## **Scope of Work for modification work in 2-Tier LHB AC Coaches**

**Name of work-** “Segregation of 110V DC +VE & -VE cables at all levels and provision of cage clamp Terminals with Glass Fuses for enhanced fire safety in LHB EOG AC Coaches as per CAI no. ED/CAI/033 dated 02.04.2024” in 2-Tier LHB AC coaches.

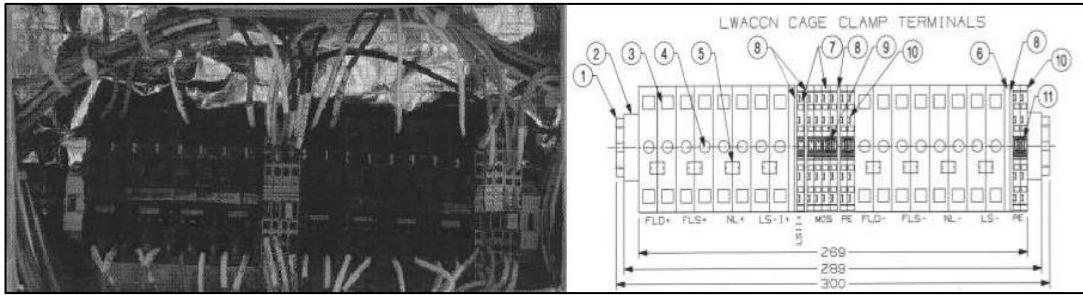
Additional hole on side wall member to be done to tight the Triple conduit clamp (shown below) that shall be used to hold 3 conduit pipes.

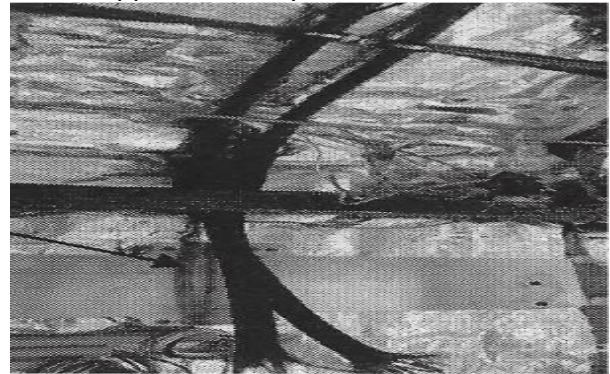
11. Supply and provision of Cage Clamp Terminals with Glass Fuses as per EDML-230, in place of existing WAGO connector mounted on side wall as shown in below picture.

Din rail of length 300 mm shall be mounted at 15 mm below the existing terminal strip mounting location for accessibility on the same WAGO Bracket. Accordingly, connections shall be done. Required material to be supplied by the contractor.

Existing Scheme

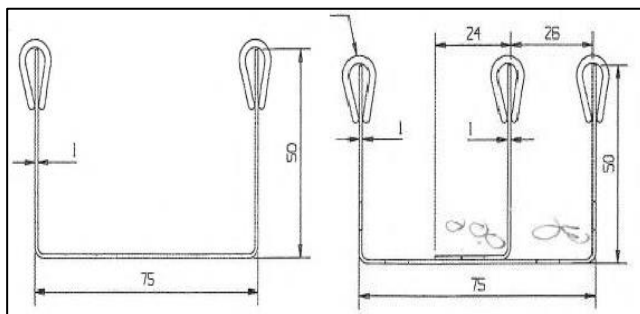
12. (1) Segregation of 110V DC +VE & -VE shall be done in Branch wiring by providing extra NW-12 flexible conduit, however due to only 01 No. Cable drop hole in Cant-rail for passing of NW-12 Conduit, branch wiring shall be done with Cable Jackets form the hole to Terminal Strip for routing of cables Through 01 no. hole. These two Conduits shall be clamped with 02 nos. Tube clamps at the roof. Additional sleeve shall be used for routing of cables separately form conduit to equipment i.e. Limit Switch, Lights. All Cable jackets/sleeves of suitable size required to complete the work shall be supplied by the contractor.

Existing cable tray

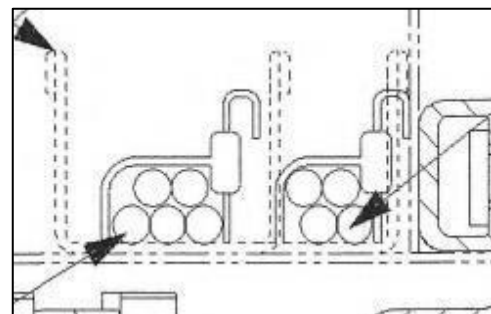
(2) The existing cable tray arrangement to Drawing No. LW44174, Item-6 Length= 18000 mm shall be replaced with Drawing No. LW44174, item-4, Length = 18000mm with provision of partition between Cable tray for segregation of DC+VE & -VE, AC cables in Roof. The required cable tray conforming to drawing no. LW44174, item-4, Length = 18000mm with provision of partition between Cable tray shall be supplied by the contractor.

Cable tray to be provided

All +ve Cables

All -Ve cables
